**JOINT APPLICATION OF LOUISVILLE GAS)
AND ELECTRIC COMPANY AND KENTUCKY)
UTILITIES COMPANY FOR CERTIFICATES)
OF PUBLIC CONVENIENCE AND NECESSITY)
FOR THE CONSTRUCTION OF A COMBINED) CASE NO. 2014-00002
CYCLE COMBUSTION TURBINE AT THE)
GREEN RIVER GENERATING STATION AND)
A SOLAR PHOTOVOLTAIC FACILITY AT THE)
E.W. BROWN GENERATING STATION)**

**RESPONSE OF
LOUISVILLE GAS AND ELECTRIC COMPANY
AND KENTUCKY UTILITIES COMPANY
TO THE COMMISSION STAFF'S FIRST INFORMATION REQUEST
DATED MARCH 13, 2014**

FILED: MARCH 27, 2014

Main simulation results

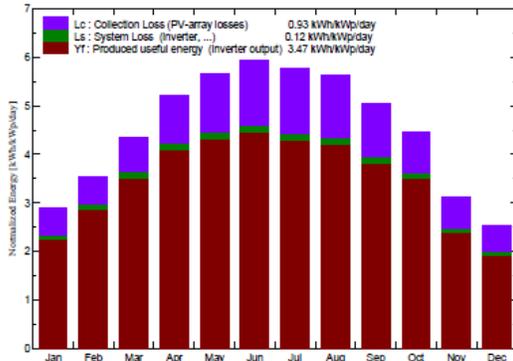
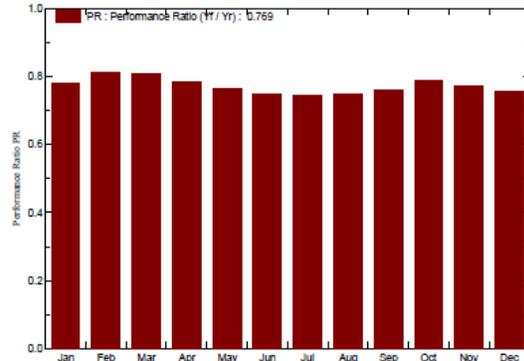
- Q-28. State whether Kentucky is geographically situated for a solar facility based upon the solar power resource available expressed in kWh/m²/day.

- a. What average daily output do the Companies project for the Brown Station Solar Facility?
 - b. State whether the Brown Station solar output projections will vary monthly/seasonally.

- b. Yes, the output will vary daily, monthly and seasonally. In the Siting Study Review performed by HDR for the Brown facility, the PVSyst modeling software produced the following average monthly energy production chart for the site.

Produced Energy 15215678 kWh/year Specific prod. 1268 kWh/kWp/year
Performance Ratio PR 76.9 %
